UNITED STATES PATENT AND TRADEMARK OFFICE

APPLICATION NO.	FILING DATE	FIRST NAMED INVENTOR	ATTORNEY DOCKET NO.	CONFIRMATION NO.
10/826,272	04/19/2004	Kazuhiro Fujii	SN-US045038	9912
22919 7590 04/18/2007 GLOBAL IP COUNSELORS, LLP 1233 20TH STREET, NW, SUITE 700 WASHINGTON, DC 20036-2680			EXAMINER LUONG, VINH	
			ART UNIT 3682	PAPER NUMBER
SHORTENED STATUTORY PERIOD OF RESPONSE			MAIL DATE	
3 MONTHS			04/18/2007	
			DELIVERY MODE PAPER

Office Action Summary

ATTACHMENT 1

FIG. 2

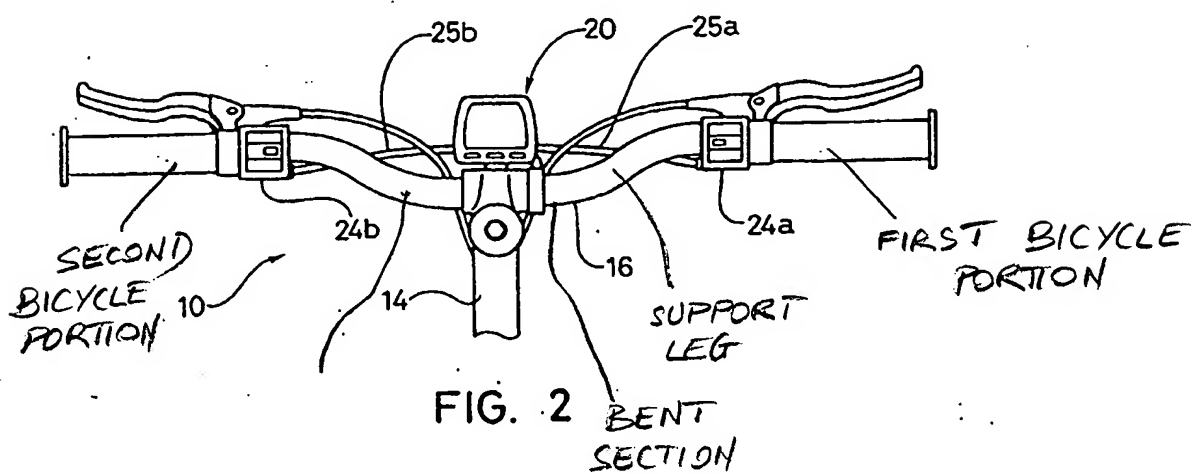
a mounting portion 41 (FIGS. 3, 9, etc.) configured to be selectively secured to a bicycle portion (i.e., a handgrip) of a bicycle (FIG. 2, see Attachment 1 hereinafter "Att. 1"), the mounting portion 41 including a switch mounting structure (unnumbered, see, e.g., FIGS. 9 and 10 of Att. 1); and

Regarding claim 6, the operating axis P of the operating member 42 is capable of being non-parallel to a center axis of the portion (FIG. 2 of Att. 1) of the bicycle as seen by adjusting the position of the mounting portion 41 along the handle bar 16 as seen in FIG. 2.

Regarding claim 11, Ichida teaches an electrical bicycle shift control assembly comprising: a first shift control device 24a (FIG. 2) including a first mounting portion 41 (Att. 1) configured to be selectively secured to a first (right handgrip) bicycle portion of a bicycle 10 (FIG. 2 of Att. 1) and a first electrical shift control switch portion 40 mounted to the first

Regarding claim 13, the first mounting portion 41 includes a band section (FIG. 9 of Att. 1) and a computer support leg 16 (FIG. 2 of Att. 1) extending from the band section, and the bicycle computer unit 20 is attached to the computer support leg 16 of the first mounting portion.

Regarding claim 14, the computer support leg 16 includes a bent section (FIG. 2 of Att. 1) such that the bicycle computer unit 20 is longitudinally offset from the band section (FIG. 9 of Att. 1) along the first bicycle portion (FIG. 2 of Att. 1).

FIG. 4

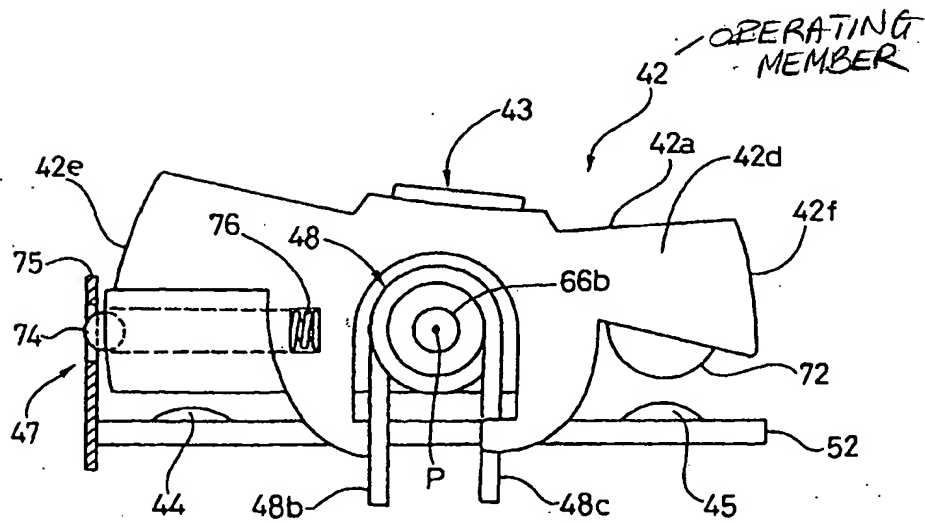
Regarding claim 3, the operating member 42 is further arranged and configured to be selectively moved relative to the mounting portion 41 between the neutral position (FIG. 4, see Brief Description of the Drawings) and a second actuating position (FIG. 6) that is spaced from the first actuating position (FIG. 5).

Regarding claim 5, the operating member 42 of the electrical shift control switch portion 40 is further arranged and configured to rotate about an operating axis P (FIGS. 4, 15, 16, and 18) between the neutral position and the first and second actuating positions. See paragraph [0032] and claims 1-35.

Regarding claim 7, the operating member 42 of the electrical shift control switch portion 40 is further arranged and configured such that the first and second actuating positions are arranged on opposite sides of the neutral position (FIGS. 4-6).

FIG. 9

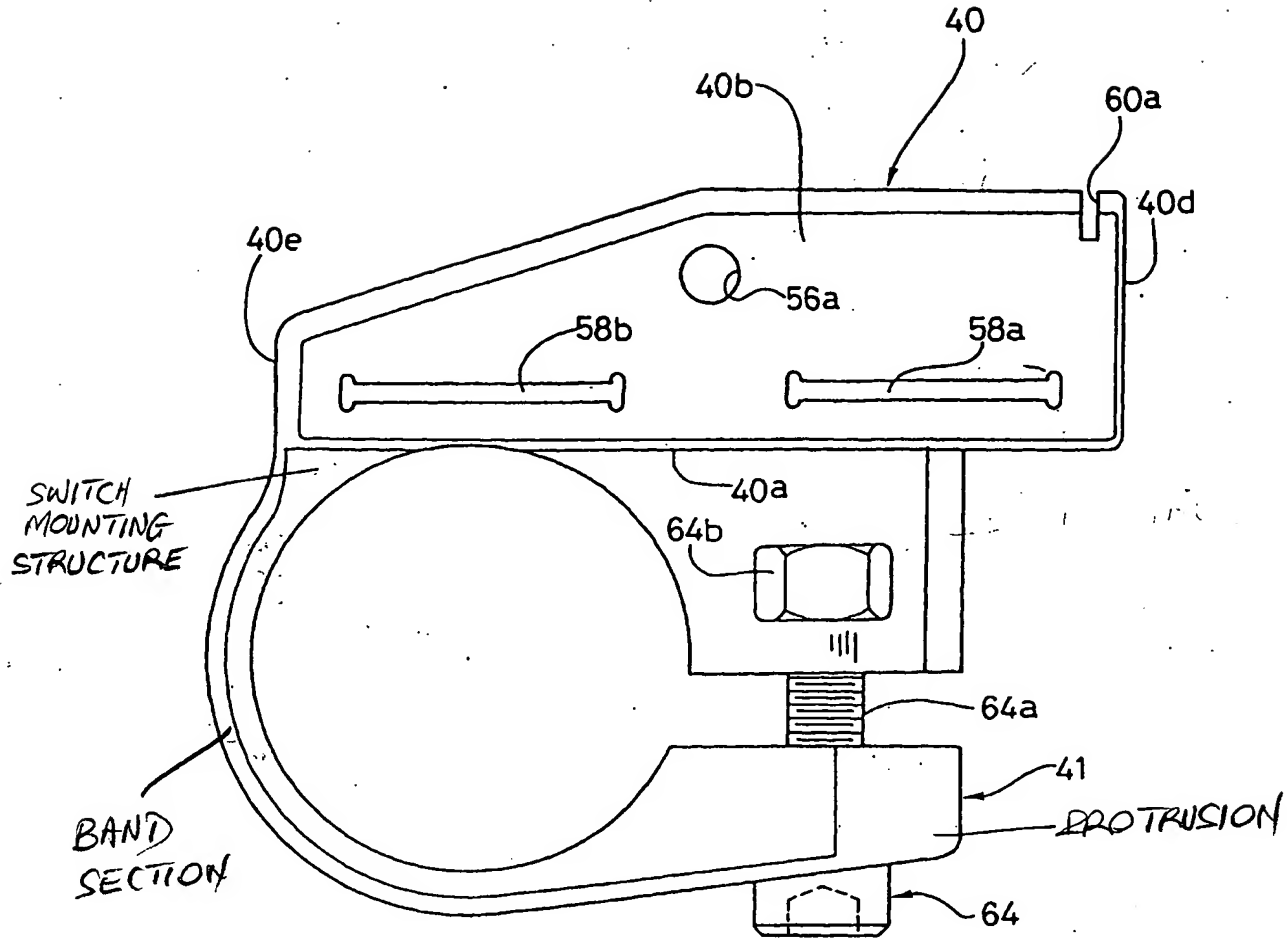
Regarding claim 2, the mating mounting structure and the switch mounting structure (Att. 1) include a protrusion (FIGS. 9 and 10) and recess 50 (FIG. 8, paragraph [0034]-[0036]) arrangement that are releasably coupled together by a fastener 64 such that the mating mounting structure is movable relative to the switch mounting structure (Att. 1) when the fastener 64 is removed.

Fig. 8

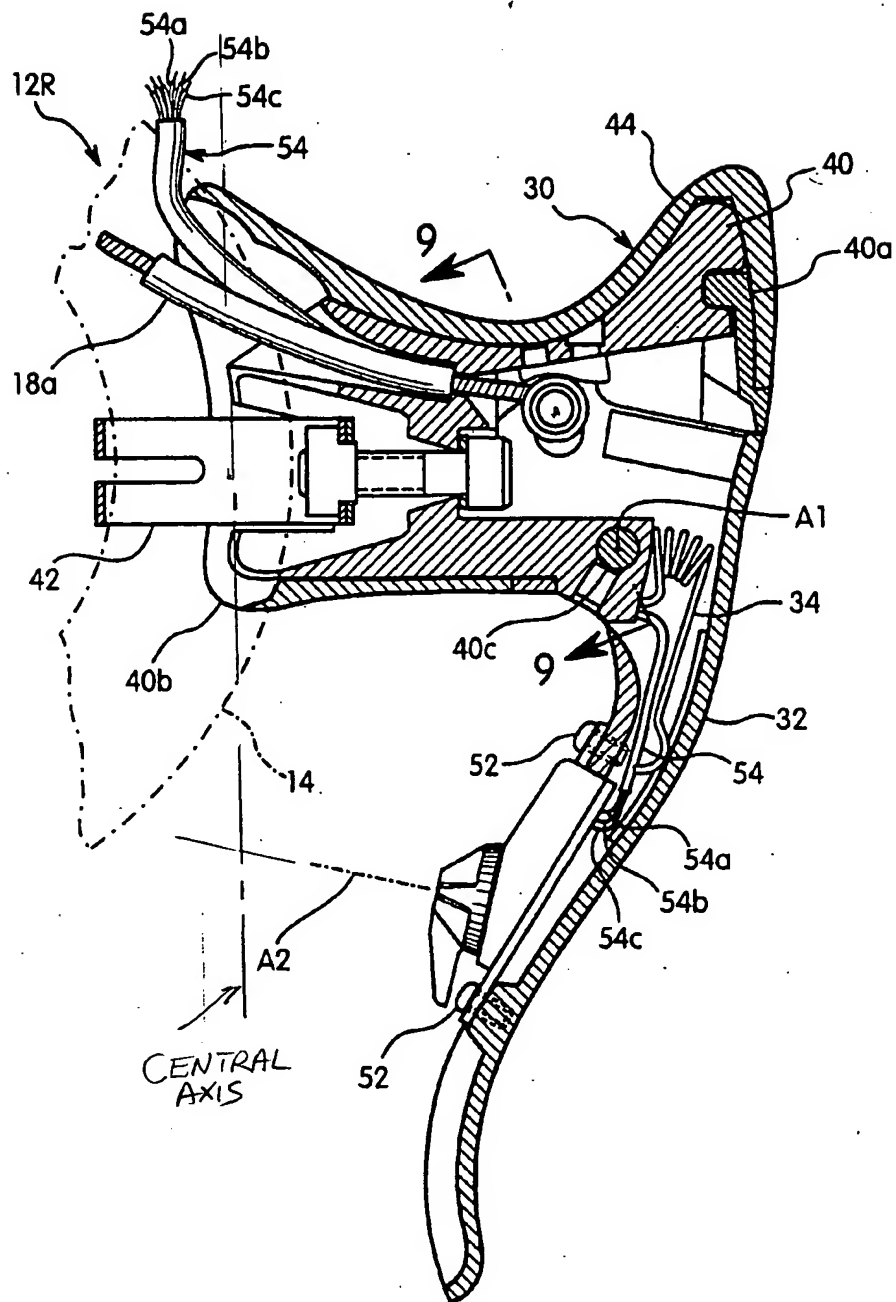
Regarding 22, Uno teaches an electrical bicycle shift control device 36, 38 (see col. 9, line 54 through col. 10, line 2) comprising a mounting portion 42, 40 (FIG. 8) configured to be clamped onto a portion 14 of a bicycle; and an electrical shift control switch portion 60, 61 (FIG. 11) coupled to the mounting portion 42, 40, the electrical shift control switch portion 61, 60 including an operating member 61 arranged and configured to move relative to the mounting portion 42, 40 between a neutral position and a first actuating position, the operating member 61 including a dial-shaped element 70 that is configured and arranged to rotate about an operating axis A2, A3 to move the operating member 61 between the neutral position and the first actuating position.

Regarding claim 26, the mounting portion 42, 40 includes a curved mounting surface 42 extending about a central axis (see FIG. 8 of Attachment 2 hereinafter "Att. 2") to contact the bicycle portion 14 and the operating axis A2 is non-parallel to the central axis (Att. 2).

Regarding claim 27, the operating axis A2 intersects the curved mounting surface 42 of the mounting portion 42, 40 as seen in, e.g., FIG. 8.

Regarding claim 1, Uno teaches an electrical bicycle shift control device 36, 38 comprising a mounting portion 42, 40, 32 (FIG. 8) configured to be selectively secured to a bicycle portion 14 of a bicycle, the mounting portion 42, 40, 32 including a switch mounting structure 40, 32 (id. col. 5, line 57 through col. 6, line 14); and an electrical shift control switch portion 60, 61 (FIG. 11) including a mating mounting structure 52 detachably coupled to the switch mounting structure 40, 32 and an operating member 61 arranged and configured to move relative to the mounting portion 42, 40, 32 between a neutral position and a first actuating position, the mating mounting structure 52 of the electrical shift control switch portion 60, 61 cooperating with the switch mounting structure 42, 32 such that the electrical control switch
